Re: Wissman 323.91 Acre Tract Subdivision

MDP # 777A

WISSMAN TRACT
 323.91 ACRE TRACT
 MASTER DEVELOPMENT PLAN

JOB NO. 5293-00
 DATE SEPTEMBER 2004
 DESIGNER AKP
 CHECKED SLW DRAWN AKP
 SHEET C100

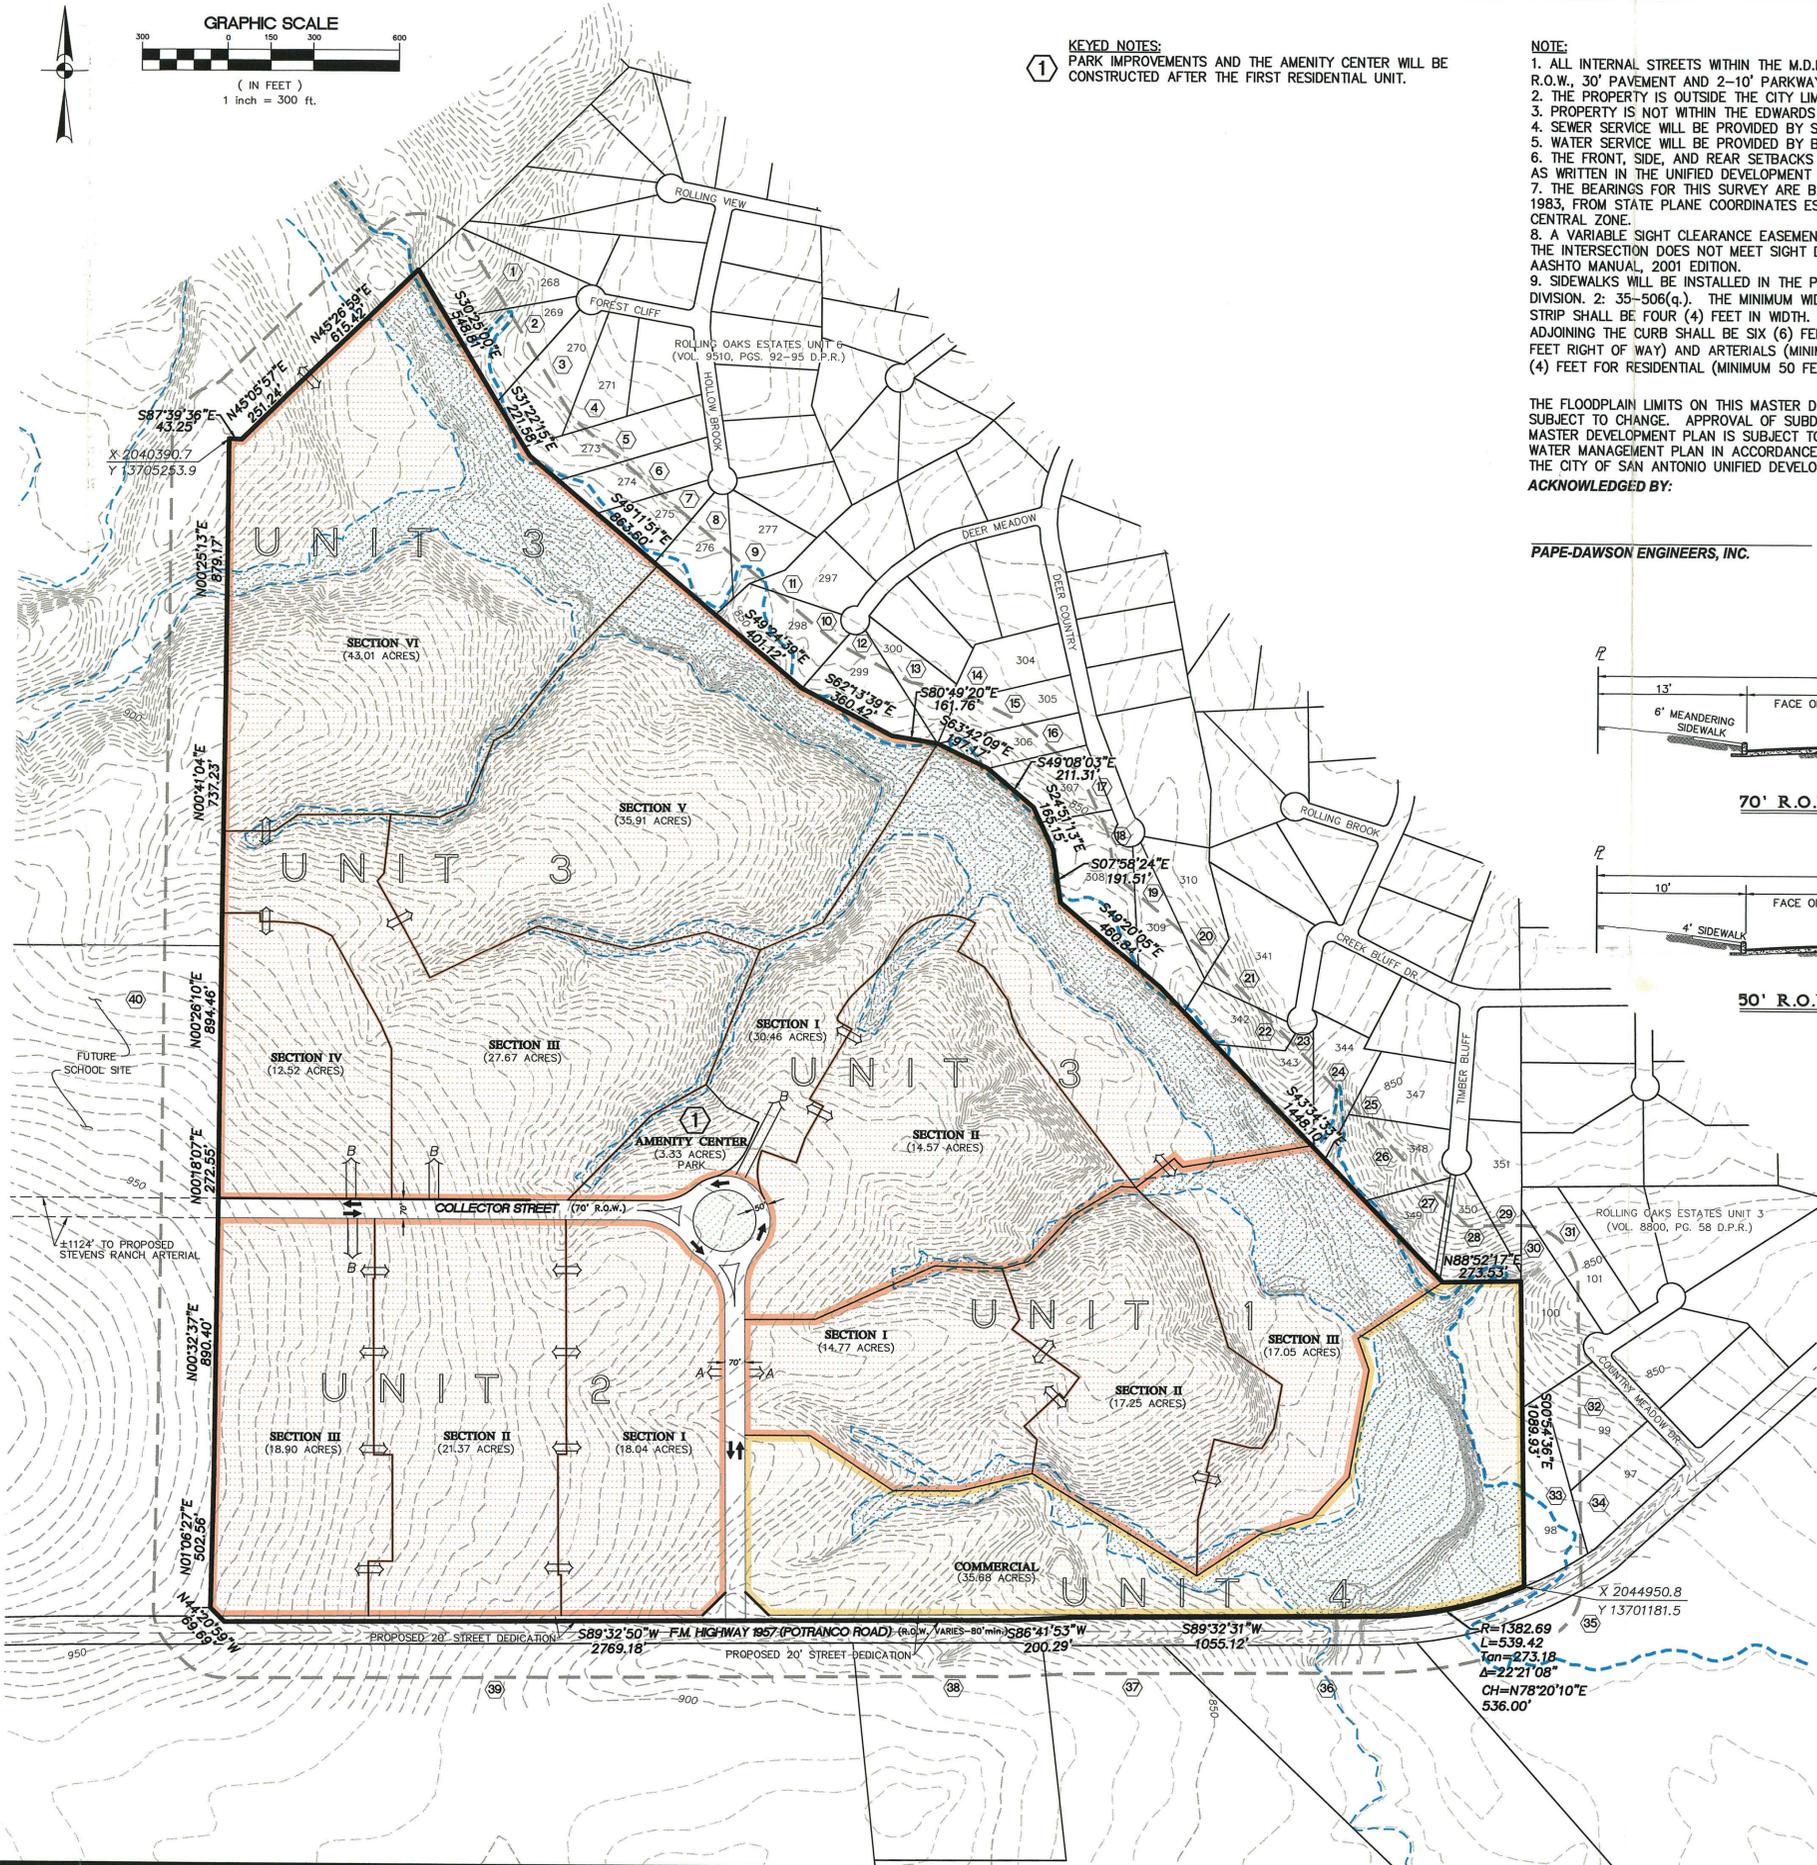
- In consideration of public safety and convenience, excessive grades by reason of topography should be avoided in street layouts and arrangements.
- The acceptance of this Master Development Plan # 777A is confined to the boundary limits of the site. Any projection(s) of future roadways outside the boundaries does not infer any set alignment of future roadways. All major arterials and streets shall follow all regulations.
- Any access and R.O.W. issues along state facilities will need to be resolved with the Texas Department of Transportation (TXDOT). For information about these requirements you can contact TXDOT at 615-5814.
- It will be expected that you will plat all of the property depicted in your Master Development Plan (M.D.P.) to include floodplains, drainage areas and open space.
- Historic Preservation Office cites the following condition:

- Streets and Drainage approves this project with the following conditions:

It should be understood that this is a general review of a conceptual plan and that all technical requirements of the Unified Development Code for Streets and Drainage shall be complied with.

- This project will be subject to the Streetscape standards and the 2003 Tree Preservation ordinance. If you have any further questions, please (210) 207-0278.
- Parks and Open Space cites the following conditions:

1. A 7.57-acre Park is proposed to include a playground, trails, and picnic areas. Additionally, the applicant states that additional improvements will be included to earn credit against the park dedication requirement. A recreation center and swimming pool is proposed for a total of 4.0 acres of credit. The recreation center must be a minimum of 1,000 square feet and the swimming pool must have a minimum of 2,500 square feet of water surface area.

2. The combination of land and credits exceeds the requirements.

3. The construction of the park may be deferred to after the first residential unit, but must be completed prior to the platting of subsequent units.

1. It is understood that this MDP is a conceptual plan and all regulations will be addressed at time of platting.

2. County reserves the right to address driveways, street design, sight distance, ADA requirements, drainage and floodplain issues at time of platting.

3. All traffic control improvements shall conform to the Texas Manual on Uniform Traffic Control Devices.

4. Roadway configurations adjacent to and within this development shall be consistent with the recommendations set forth in the Stevens Ranch Traffic Impact Analysis dated November 2003.
